Product hierarchy no. *	Part no.	SBU	Type / Description	Customer part no.
SBU PG PUG Type				
02 007 012 0000001400	See list below	Connectors	6610 Appliance Outlet 10A 70°	-

Product Change Notification					PCN 6610 - Change of Material		
owner	creation date	release date	released by	change order no	rev	page	D10-033-108
vettorsa	19.05.2020	19.05.2020	wuillsco	2015290	B	1 of 2

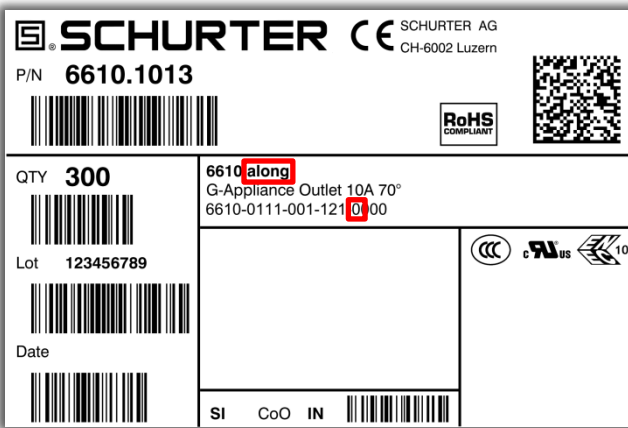
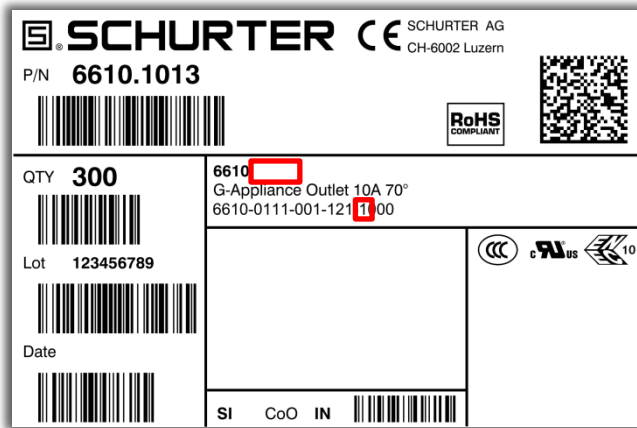
Old material	New material
Polyamid PA6 (GWIT standard / V0) Polyamid PA66 (GWIT standard / V2)	Polyamid PA6 (GWIT enhanced / V0)
Old packaging label	New packaging label
 (6610-0XXX-XXX-XX1-0XXX)	 (6610-0XXX-XXX-XX1-1XXX)

- Enhanced glow wire requirements
- Material consolidation
- Appearance consolidation (colour of the front surface according to 4710-5)
- Configuration code changed because of enhanced glow wire requirements.

Orders placed after WW20/20 are manufactured with the new material. The change is traceable on the label by the printed configuration code.
